UNITED STATES  
NUCLEAR REGULATORY COMMISSION  
WASHINGTON, D.C. 20555-0001

SUBJECT: Summary of June 26 and 27, 2017 Meeting with Homestake Mining  
Company of California

**Meeting Summary from Re-injection Program and Effluent Discharge Presentation**  
**June 26 & 27, 2017**

# Report Objectives

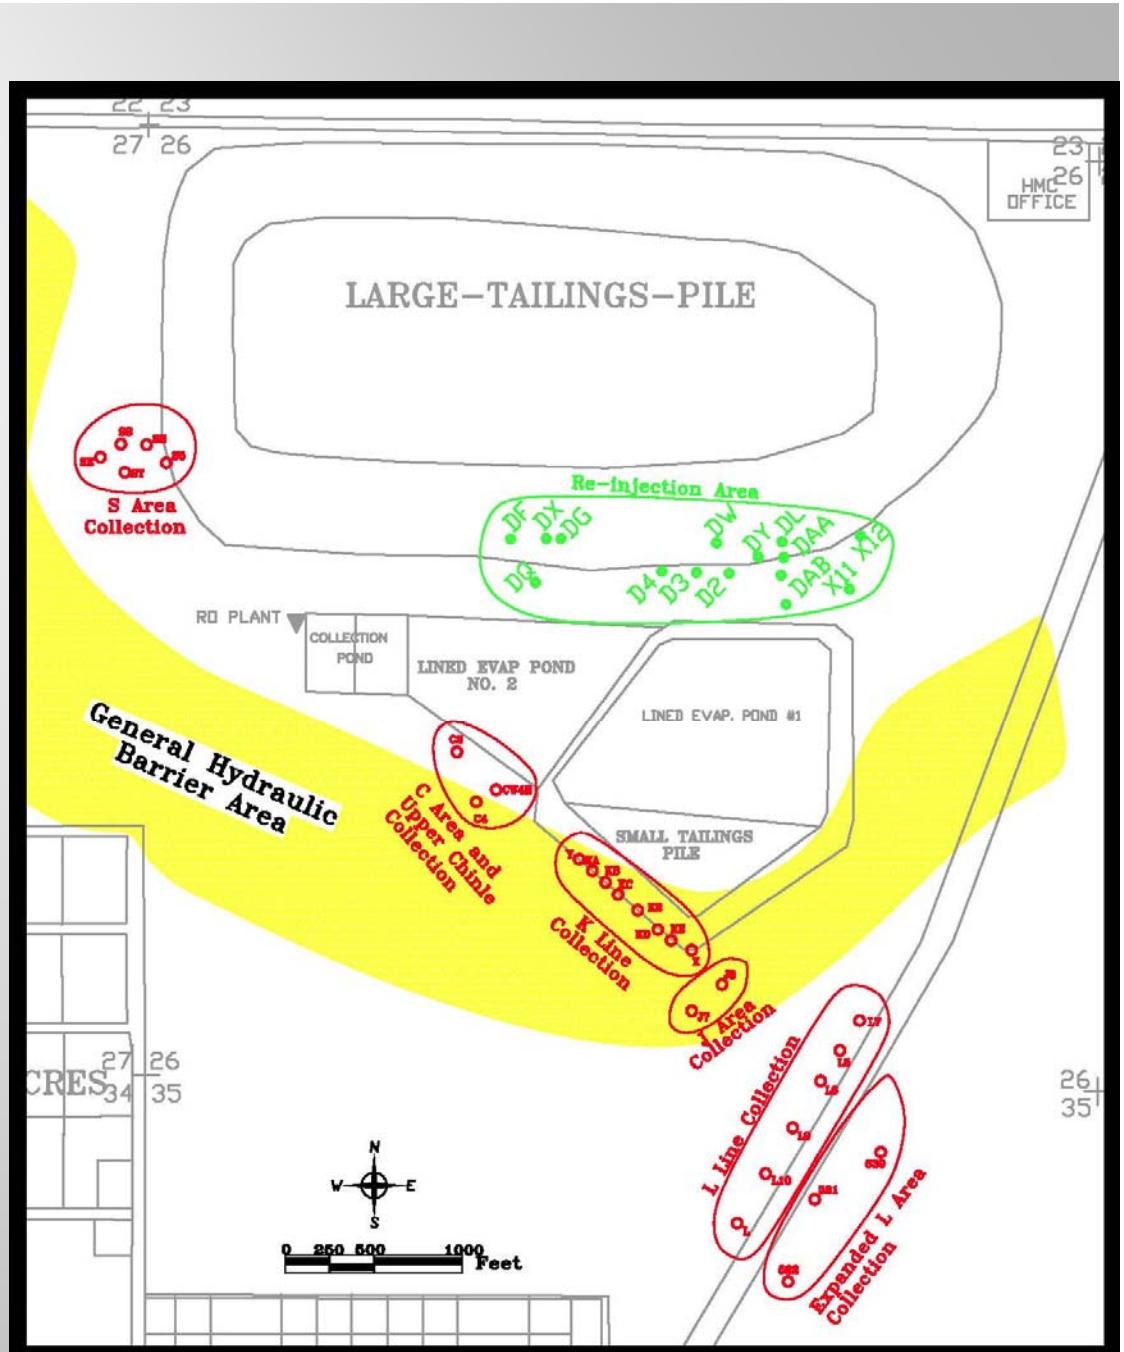
The U.S. Nuclear Regulatory Commission (NRC) staff commented that the impact analysis was highly focused on the L Collection Area rather than the impacts that may have occurred at the area depicted as the general area used for re-injection shown in slide 3. The corrective action program authorized by the NRC requires collection and treatment from impacted areas in order to achieve the estimated restoration schedule. In order to achieve the estimated restoration schedule, Homestake was already required to collect impacted water from the L Collection Area for treatment. The conclusions drawn from both assessed alternatives for the re-injection impact analysis were highly dependent on no collection taking place at the L Collection Area and the resulting expansion of the plume. While the staff agrees that the lack of collection would have resulted in an expansion of the plume, the "no action" alternative was not an option and therefore, collection from the L Collection Area should have occurred using one of the authorized methods regardless. Also, the second alternative concluded that the restoration time frame would have increased if the impacted water from the L Collection Area was transferred to either the RO plant or the evaporation ponds due to a reduction of higher impacted water being processed. The staff agrees that processing impacted water with lower concentrations would have increased the restoration time frame. However, the expected treatment rates for the RO plant were well below the expected 600 gpm of input water and approximately 420 gpm of product water due to deficiencies in the RO plant design. The RO plant was originally constructed with one 300 gpm low pressure unit followed by a high pressure unit to treat the brine from the low pressure unit. The design feed rate to the RO was limited to 300 gpm until 2002 when a second 300 gpm low pressure unit was installed, bringing the maximum RO feed rate to 600 gpm. Recent upgrades have further expanded the RO plant capacity to 1200 gpm. The RO plant should have been able to process the L Collection Area water and any deficiencies of the RO plant should have been corrected at that time. Additionally, evaporation/disposal capacity was significantly increased due to the addition of the second evaporation pond in March of 1996. Despite the addition of the second evaporation pond, total evaporation capacity continued to be a limiting factor in tailings dewatering rates and the evaporation/disposal of other collection waters. The staff commented that the re-injection impact analysis should have focused on the general area of re-injection to determine if there were any impacts to the corrective action restoration time frame based on the additional mass of uranium transferred to this area. A mass removal analysis for the re-injection area should be performed to show the mass of uranium over time and a comparison of the mass collected from the re-injection area to the mass of uranium transferred from the L Collection Area.

During a follow-up meeting on the June 27<sup>th</sup>, Homestake discussed the use of an alternative modeling approach to determine changes in the mass of uranium over time within the re-injection area. The alternate modeling approach will provide the necessary detail to determine if

there are any impacts to the remediation time frame. The NRC staff agreed the modeling approach should provide the necessary detail to determine if any impacts occurred.

The proposed modeling approach uses commercial surface and volume analysis software (Quicksurf) to perform a mass balance analysis for the re-injection area. Quicksurf runs within AutoCAD and can utilize mapping with available concentration data, water-level elevation data, water-level elevation contours and iso-concentration contours to estimate contaminant mass. When compared with the polygon-based mass balance presented in the CAP, the Quicksurf analysis can utilize available concentration data from more wells and is not restricted to those wells selected to define the polygons. The Quicksurf analysis can also be more easily focused on the area of concern within the hydraulic control area. For these reasons, the Quicksurf analysis is expected to give a more refined mass balance in the re-injection area.
